## Technical Service Bulletin

80 Coolant loss from coolant valve, engine warning light on, "Limp Home" mode active, cabin heating is insufficient

80 14 06 2033806/5 March 11, 2014. Supersedes Technical Service Bulletin Group 80 number 13-05 dated September 11, 2013 for reasons listed below.

**Figure 1.** Coolant residue in the connector housing of the coolant regulating valve.

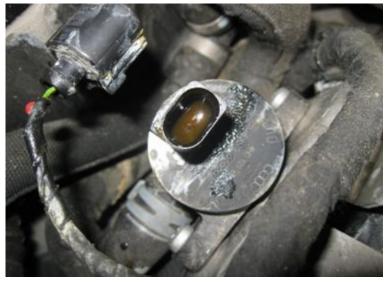
Inspection of the coolant control valves N82, N509, or N488 reveals the presence of coolant inside the electrical connector as shown in the illustration (Figure 1).

- 1. Diagnose the defective coolant valve (N82, N509, or N488) using Guided Fault Finding where stored DTCs are found.
- 2. Replace the defective coolant valve.

**Tip**: Check the connectors, wiring harness, and connected control units for coolant damage. Perform repairs as necessary.
